Summary of Changes

Narrative

RE: **5-DR-2018**
Taco Bell
6P649 (Key Code)

The Planning & Development Services Division has completed the review of the above referenced development application submitted on 8/5/2022. The following **2nd Review Comments** represent the review performed by our team and is intended to provide you with guidance for compliance with city codes, policies, and guidelines related to this application.

A4.1A

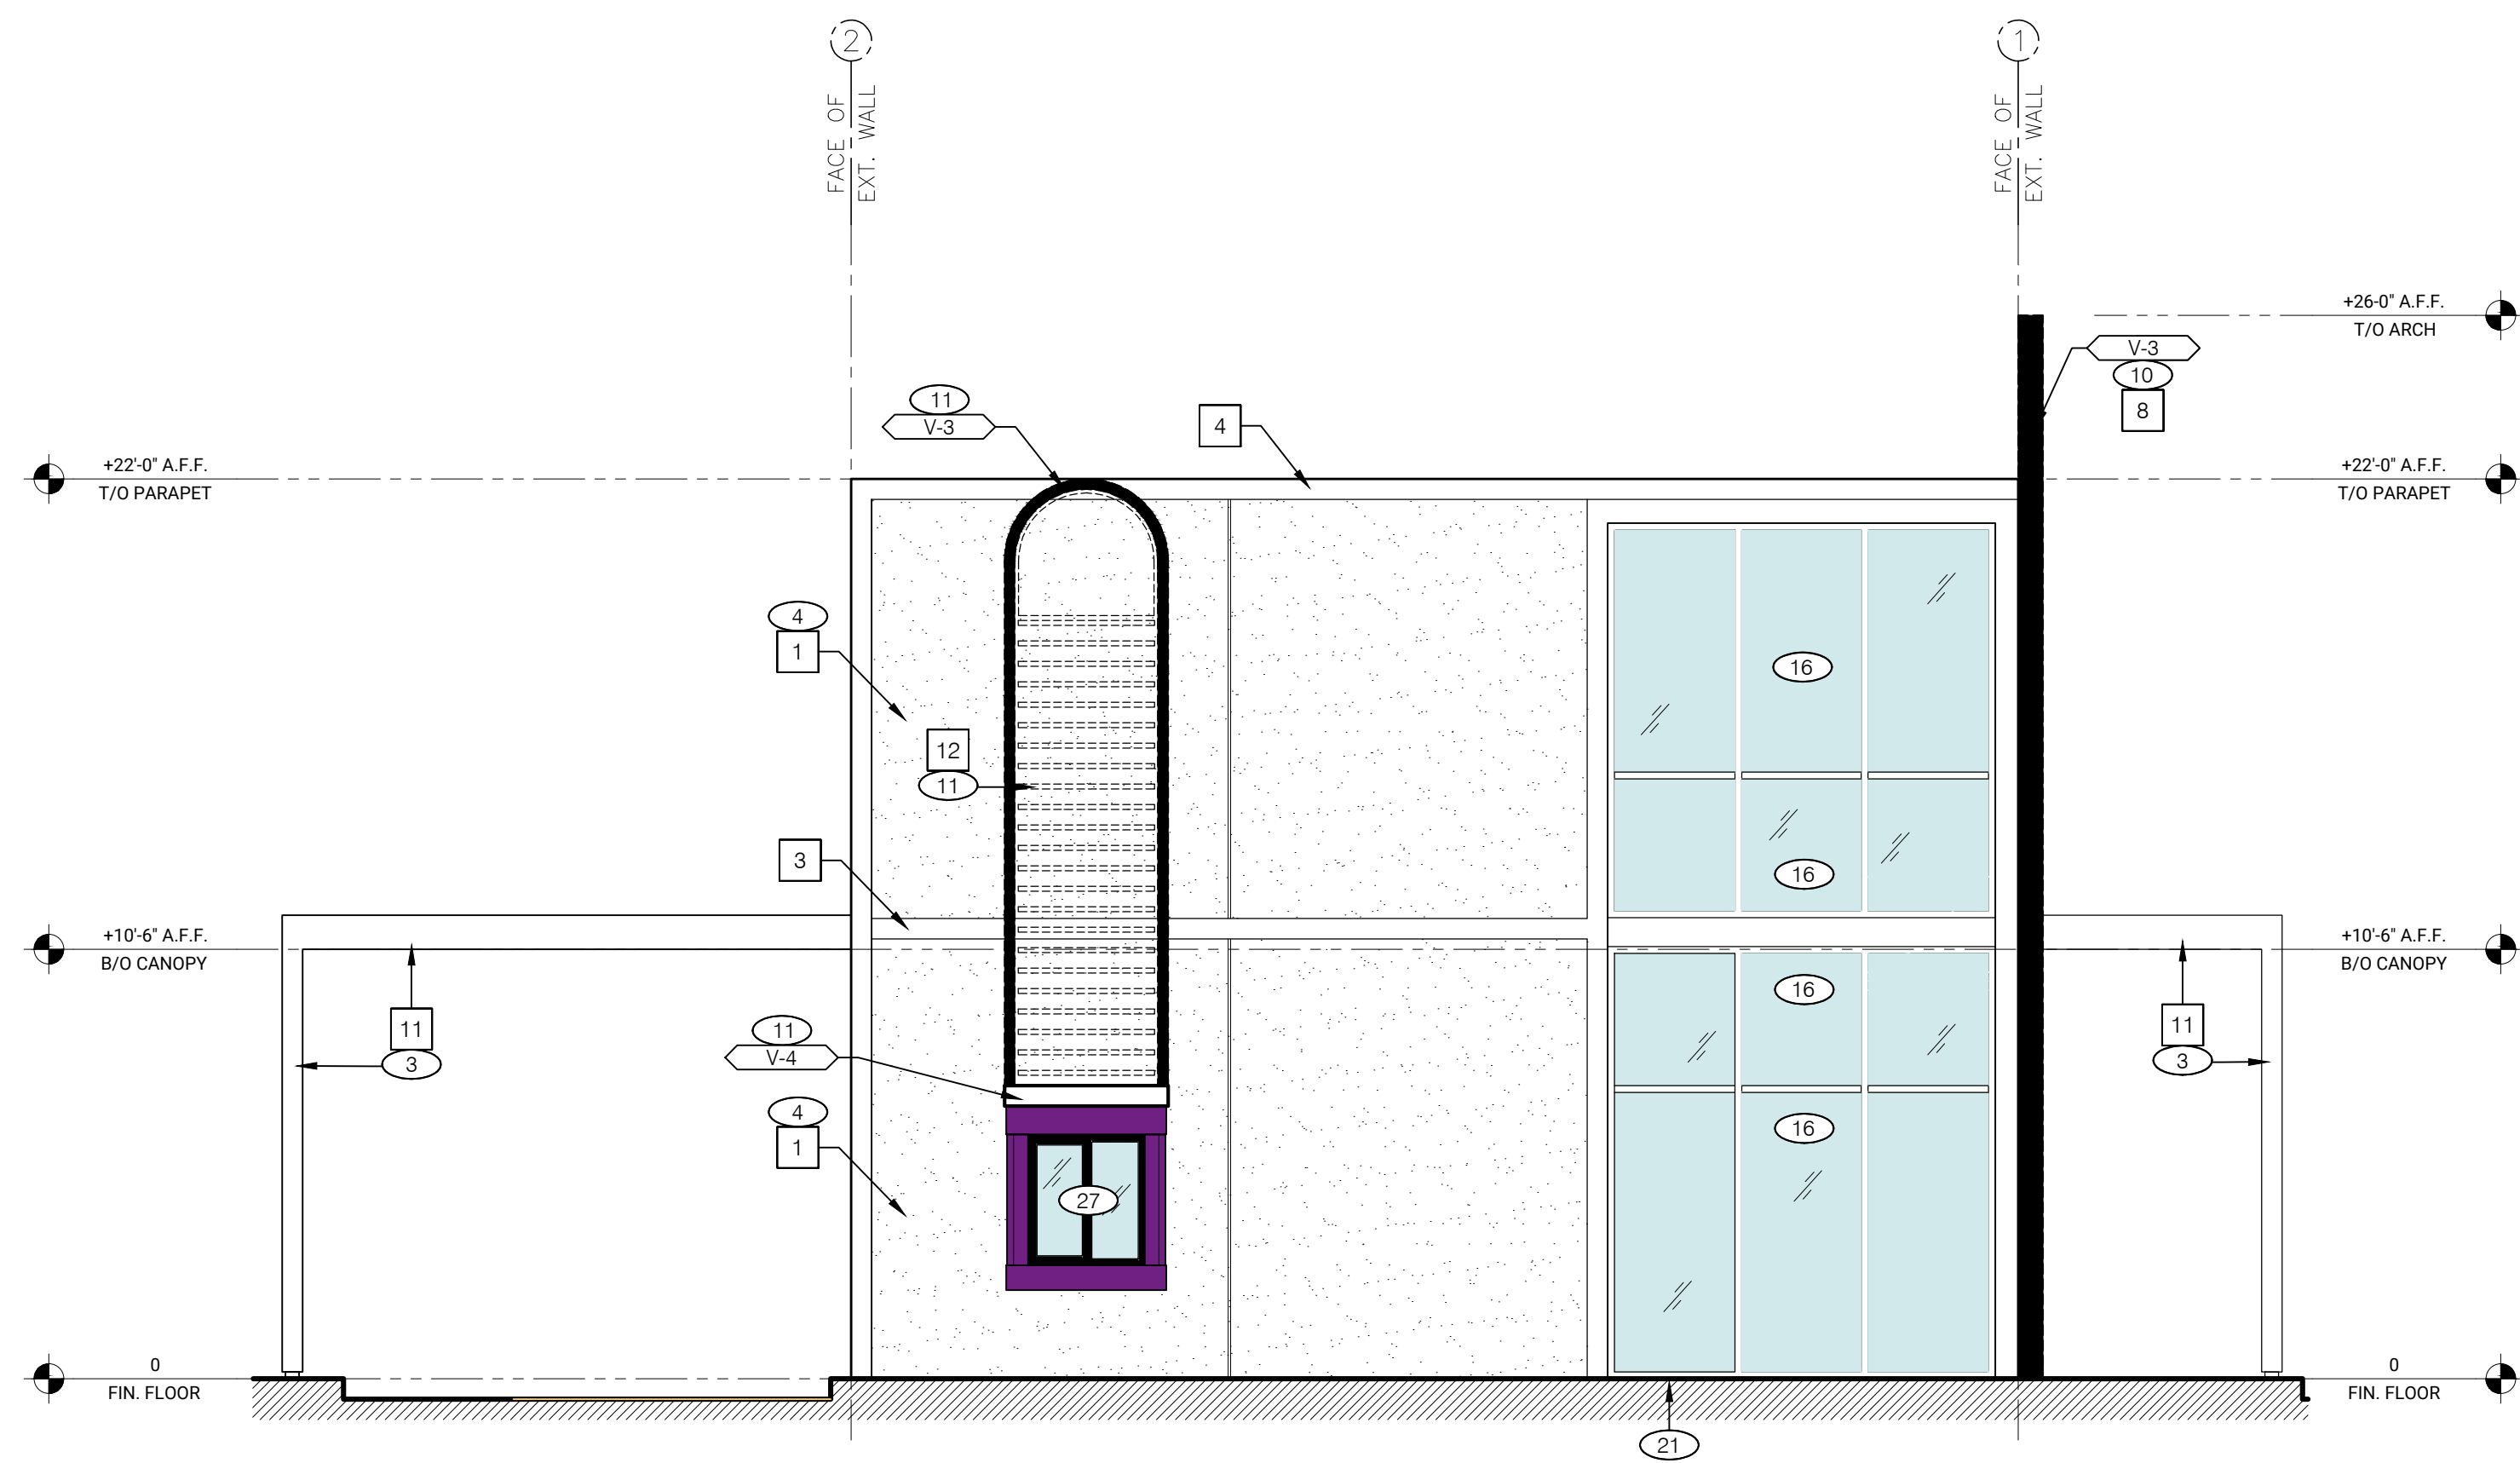
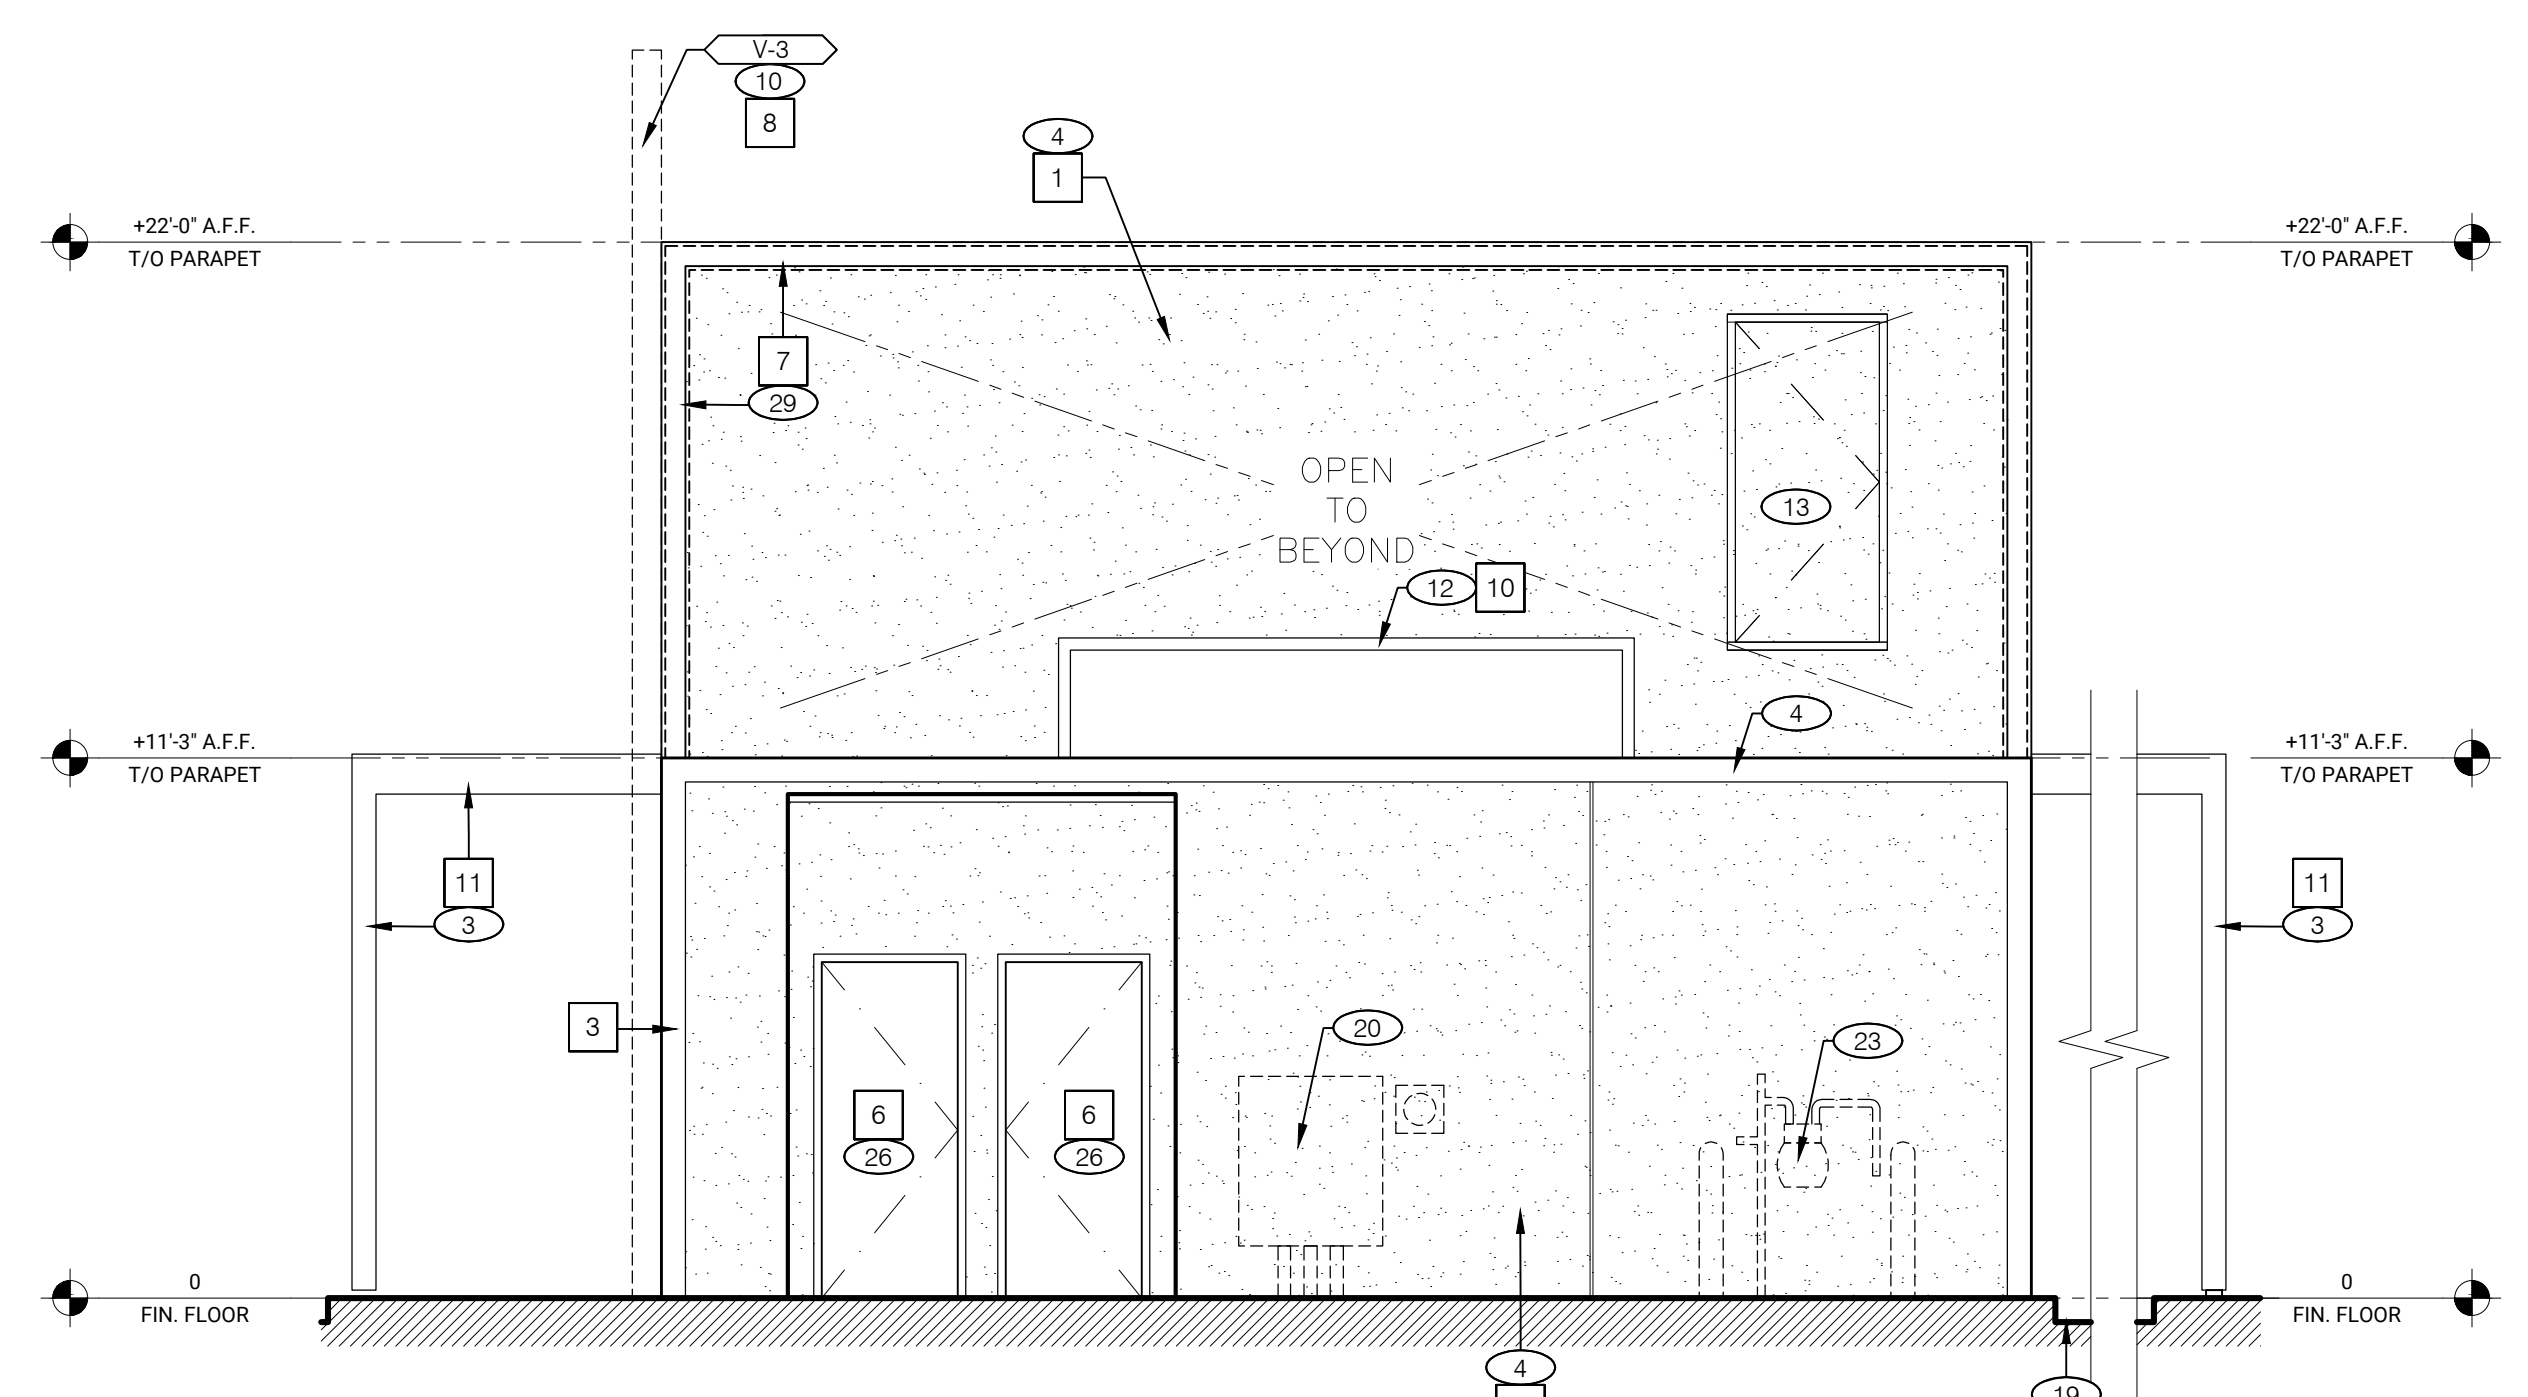
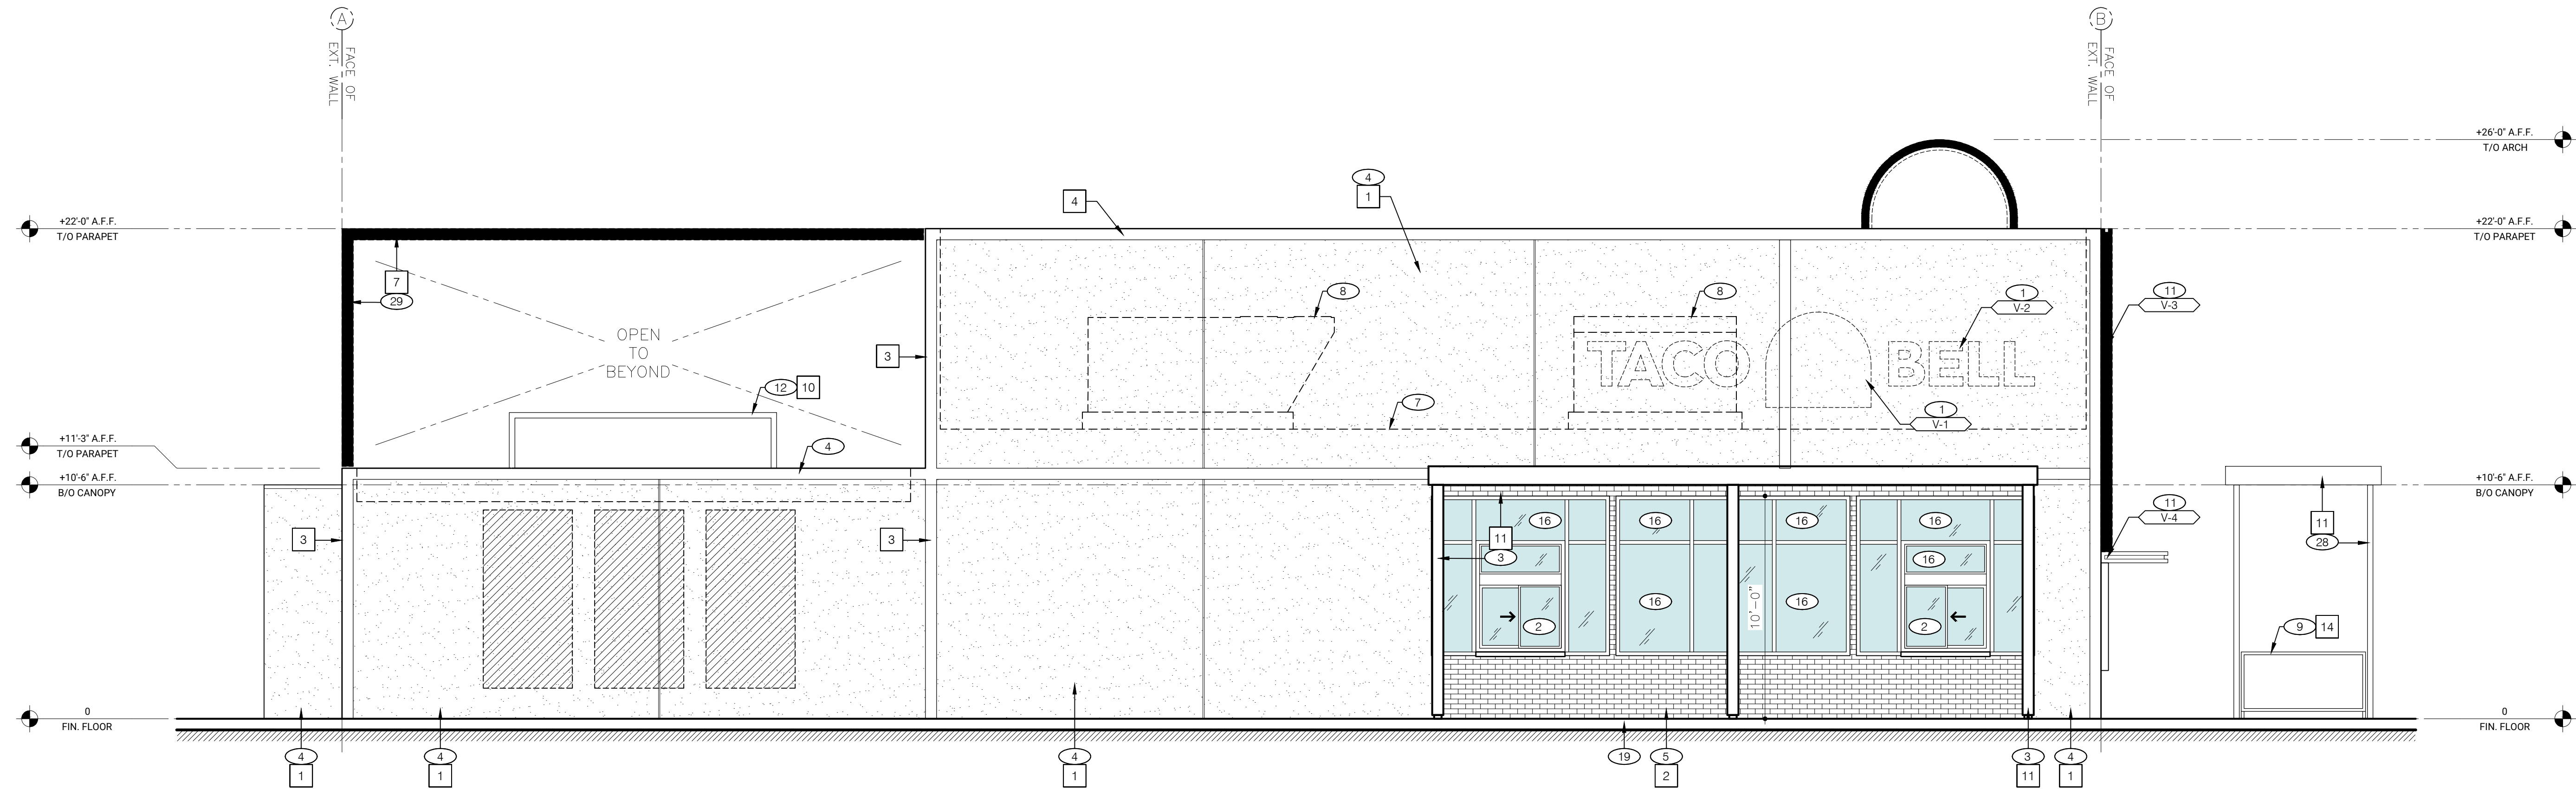
Front Elevation

1. Architectural finishes have changed.
2. Front seating canopy separated from building.
3. Exterior order window added.
4. Large tower removed.
5. Porte cochere has changed form but remains.
6. Branding and signage has changed.
7. Wainscoting removed.
8. Entrance canopy changed from turnbuckle canopy to structure.

Drive Thru Side Elevation

1. Architectural finishes have changed.
2. Pickup window layout has changed.
3. Porte cochere has changed form but remains.
4. Branding and signage has changed.
5. Wainscoting removed.
6. Rear upper wall form and open concept, with RTU screening.

Entrance Side Elevation

1. Architectural finishes have changed.
2. Entrance/egress door layout has changed.
3. Branding and signage has changed.
4. Wainscoting removed.

5. Rear upper wall form and open concept, with RTU screening.
6. Entrance parapet elements removed.

Rear Side Elevation

1. Architectural finishes have changed.
2. Branding and signage has changed.
3. Wainscoting removed.
4. Rear upper wall form and open concept, with RTU screening.
5. Rooftop access is now exterior only, with standard ladder to rear exterior door on lower roof.
6. Sprinkler/fire riser room shifted toward entrance side of building.
